Memorandum to the City of Markham Committee of Adjustment

February 7, 2020

File: B/28/19 and A/006/20
Address: 21 Lanor Court, Markham
Applicant: Harichandran Samithamby
Agent: QX4 Investments Ltd. - Consulting Services
Hearing Date: Wednesday February 5, 2020

Figure 2 Proposed Severance Plan

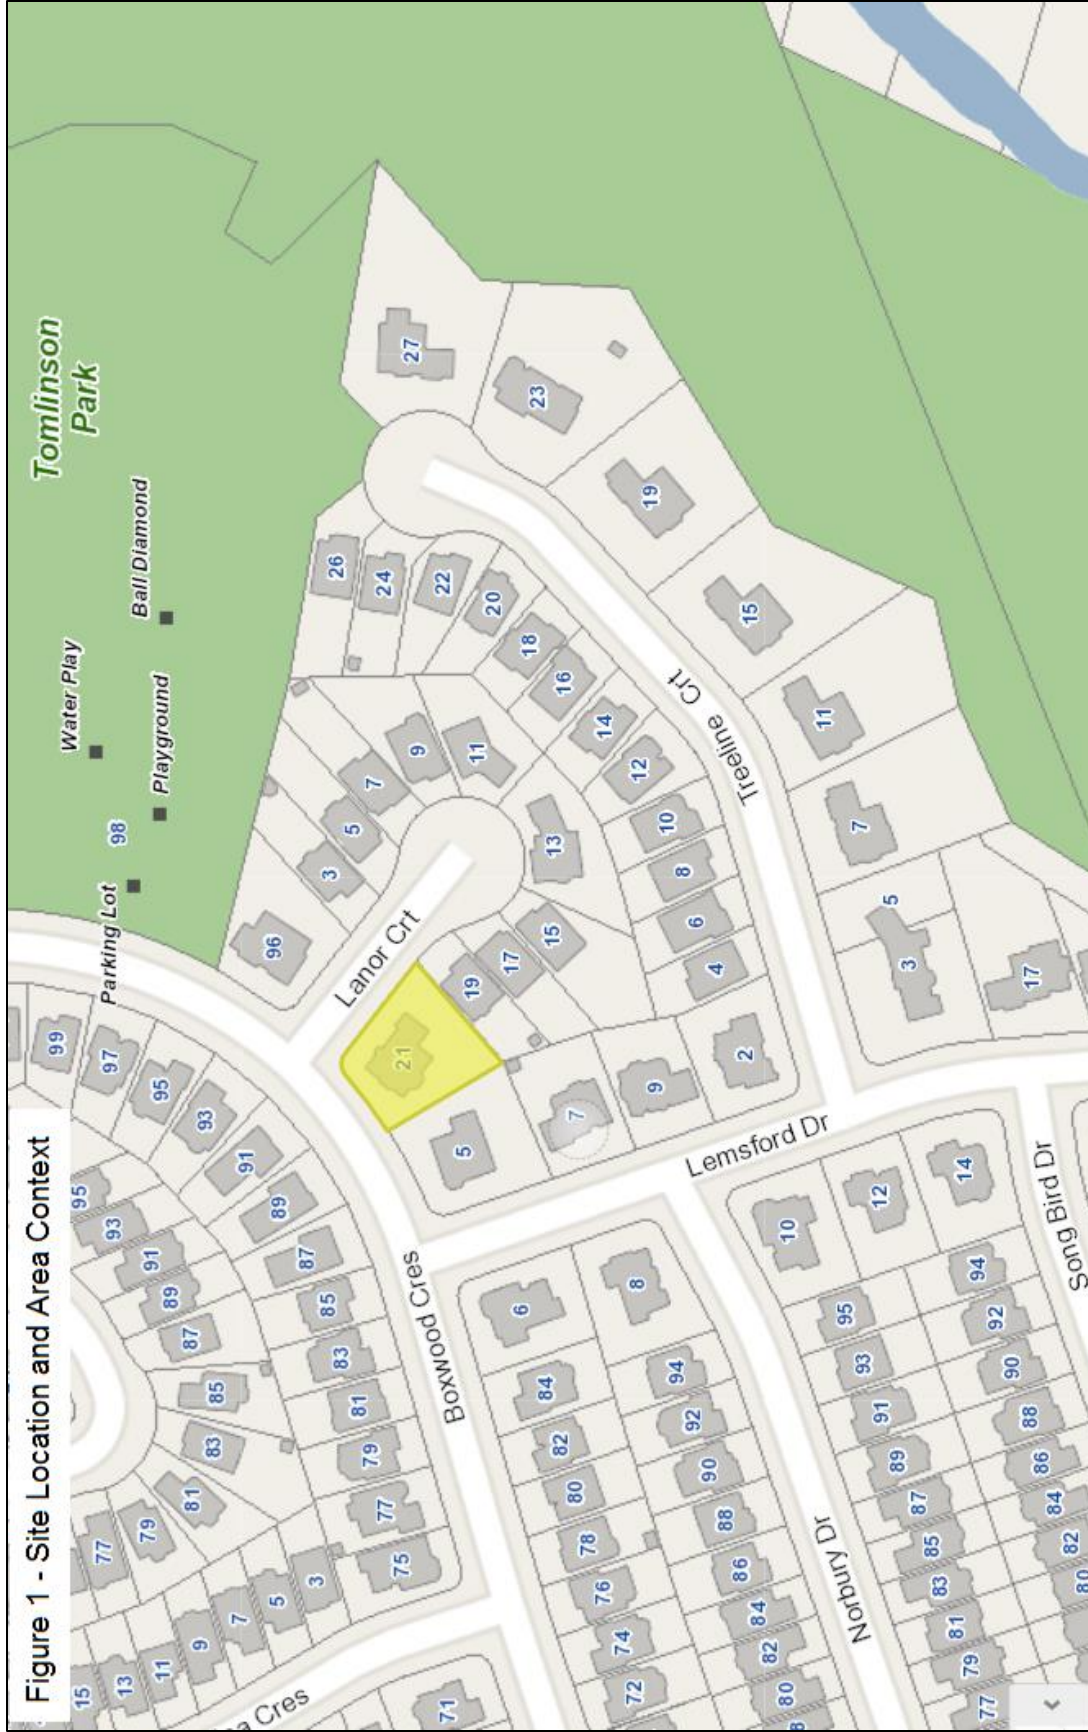
The Applicant is proposing a consent application to sever the existing lot into two parcels to create a new development lot for a new single detached dwelling on the severed parcel. The existing dwelling will remain on the retained parcel, however to facilitate proposed severance, a portion of the existing three-car garage will need to be demolished and be reconfigured as a two-car garage. Figure 2 shows the severance plan and proposed site plan.

In consideration of this consent application, staff remain of the opinion that the proposed severance is appropriate, and that any decision to approve this application should be subject to finalizing those conditions not satisfied through the 2017 application, as provided in Appendix 'C'.

Figure 3 - Site Plan

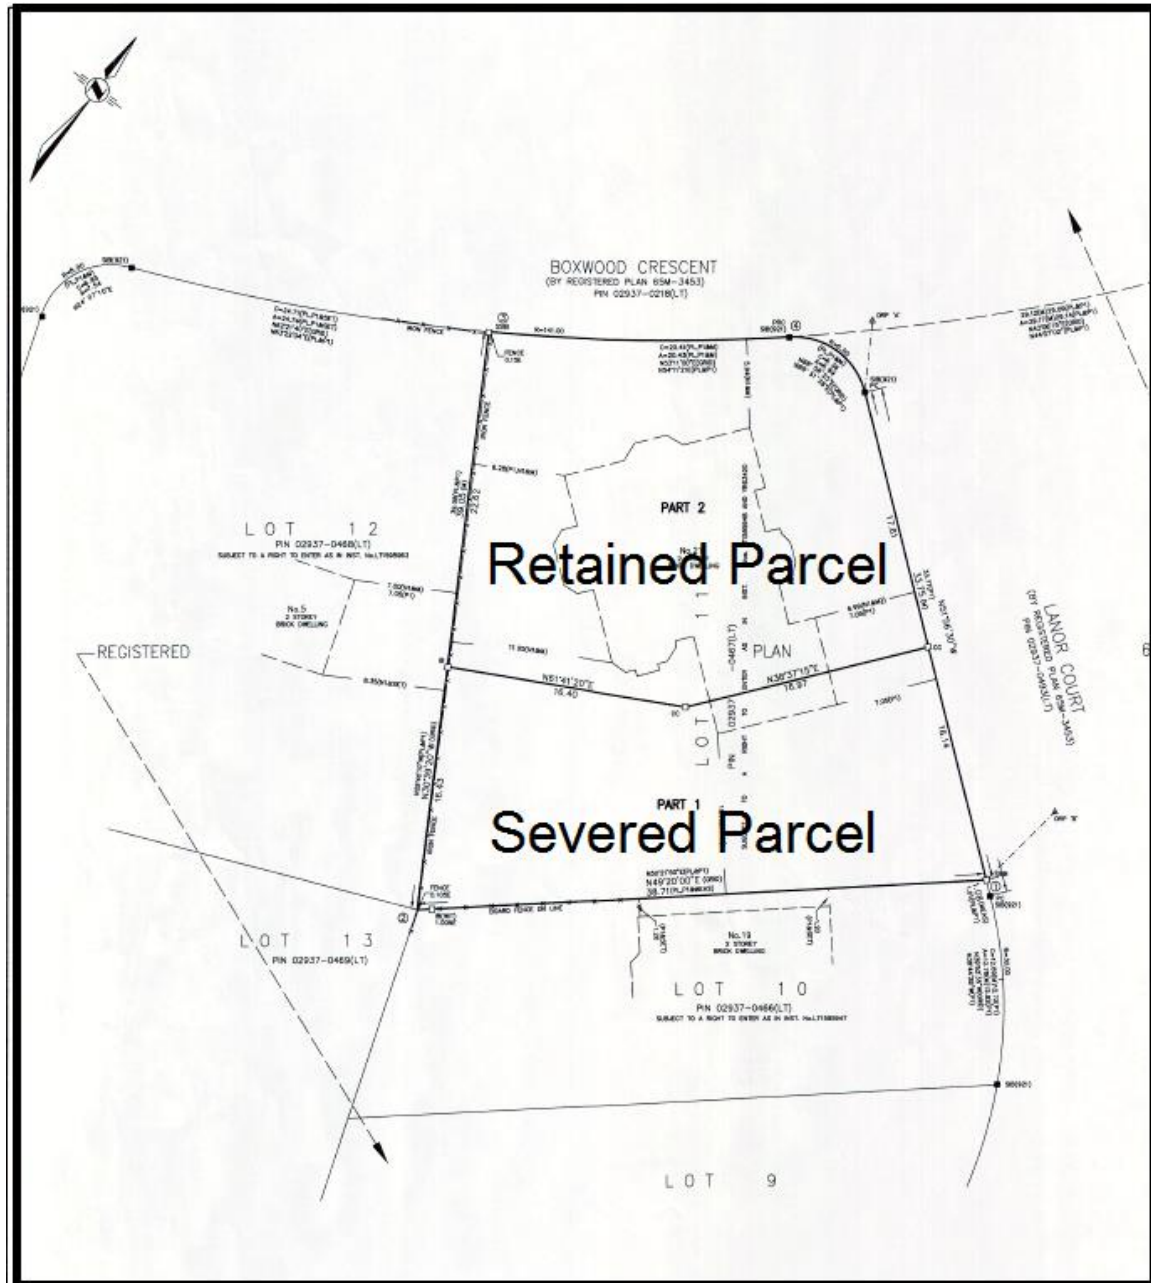
The requested rear yard setback reduction is applicable to a small portion of the proposed dwelling at its northwest corner. The majority of the rear wall complies with the minimum rear yard setback of 7.5 m. Staff note that the rear section of the proposed dwelling is one-storey in height only, and are of the opinion that the requested rear yard setback will be of no impact to abutting properties. Staff have no concerns with this requested variance, which is consistent with previous comments (Appendix B).

Additionally, the applicant has requested a new variance to permit a 2nd storey north side yard setback of 1.2 m, which is applicable to a small area of the proposed dwelling containing the stairs. This side of the proposed dwelling is adjacent to the existing home on the retained parcel, and staff do not have concerns with this request.

The applicant is requesting a maximum lot coverage of 41.01%, whereas the By-law permits a maximum lot coverage of 40%. The severed parcel is proposed to have a lot area of 516.7 m² (5661.7 ft²). Approval of this variance would permit a dwelling with a total lot coverage of 211.9 m² (2280.9 ft²) whereas the By-law permits a maximum of 206.7 (2224.9 ft²). This is a minor increase of 5.2 m² or 56 ft². However, considering that the applicant is proposing a severance to create this lot, including a variances for a reduced lot area and other development standards, it would be appropriate that new infill housing comply with the maximum lot coverage requirement. Committee should also consider the cumulative effect of the requested increased lot coverage in combination with proposed reductions to rear and side yard setbacks. Notwithstanding, staff acknowledge that the proposed lot coverage is a negligible increase that will not impact abutting properties.

- 1) The variances apply only to the proposed development as long as it remains;
- 2) That the variances apply only to the subject development, in substantial conformity with the plan(s) attached as 'Figures 3 to 6' to this Staff Report and dated May 2017 (Revision Date, December 18, 2019) and received by the by the Committee of Adjustment December 19, 2019.

Figure 6 - Elevations

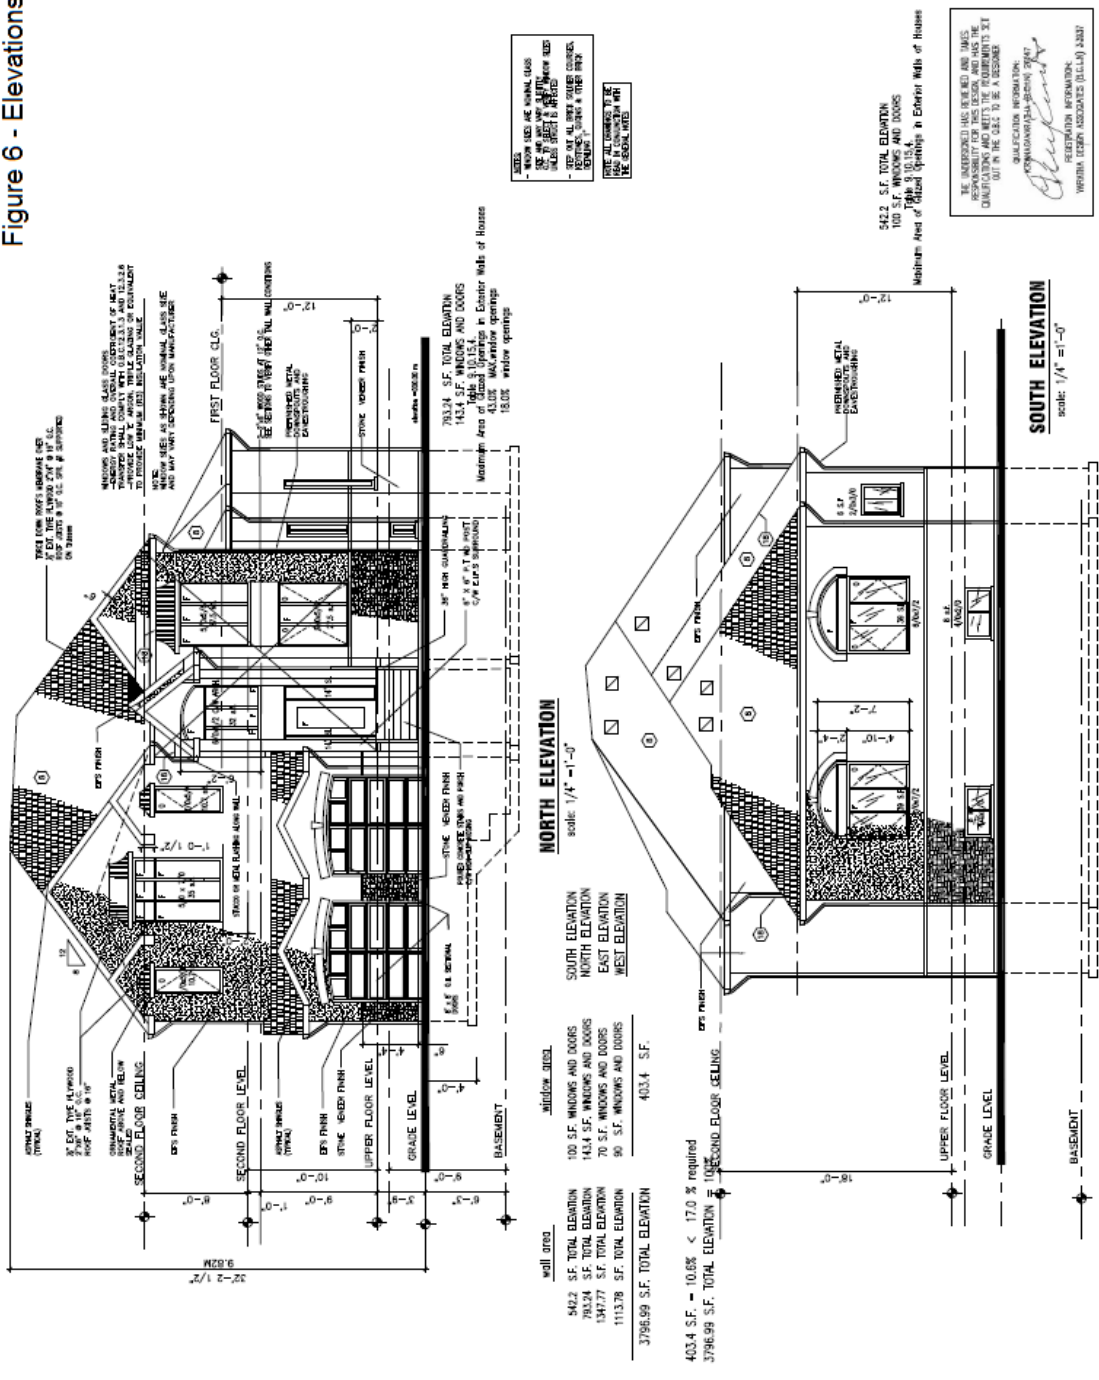
The applicant has submitted a variance application to re-request four variances approved by the Committee of Adjustment in 2018 to change conditions that approval conform to plans considered at that time. These changes included expanding the 2nd floor area space along the south portion of the dwelling, and increasing the building height, in which the front elevation height increased by approximately 1.14 m (3.74 ft). The plans considered in 2018 showed a height of 8.68 m (28.48 ft) from grade elevation to the peak of the roof, whereas the current plans show a height of 9.82 m (32.2 ft).

In review of the previous applications, staffs recommendation of approval considered the overall bulk and mass of the proposed dwelling, which was of modest scale. Staff note that the current proposal still contemplates a predominantly single storey dwelling, with second storey floor space oriented towards the front of the building. In consideration of the request to change conditions to reflect the current plan, Committee should be satisfied that the proposed dwelling will fit in with the established scale and massing of the community. Staff note that the by-law permits a maximum building height of 10.7 m (35.1 ft) measured from established grade to the mid-point of a pitched roof, and that the proposed dwelling complies with this requirement.
